**ADDENDUM No. 2**  
**REQUEST FOR TENDER ARIBA Doc3851217981**  
**CLOSING DATE (REVISED): 12:00 NOON (LOCAL TIME), June 6, 2023**  
**For: New Dental Clinic Located at 240 Alton Towers Circle, Toronto**

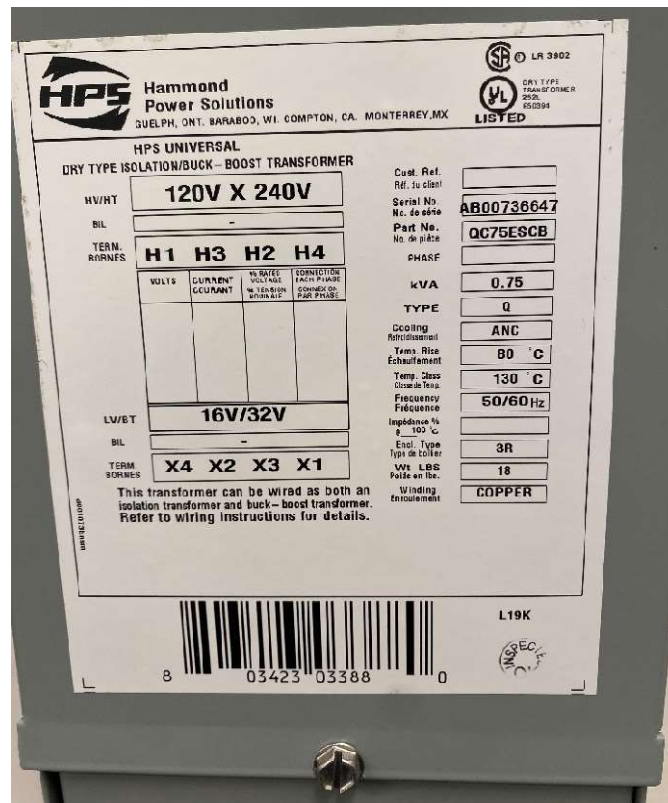
**Q1: Please advise which doors get the PDO they are not indicated on the door schedule.**

**A1:** As noted on the Door Schedule with 'PPA' and on Drawings ID1.03 Power and Communications Plans and E004-R8 Power/Data/Voice Layout with 'DO' symbol, the following doors shall be equipped with a power door operator c/w hands free (wave) actuator:

D300A  
D300B  
D301A  
D308  
D309  
D310  
D310A
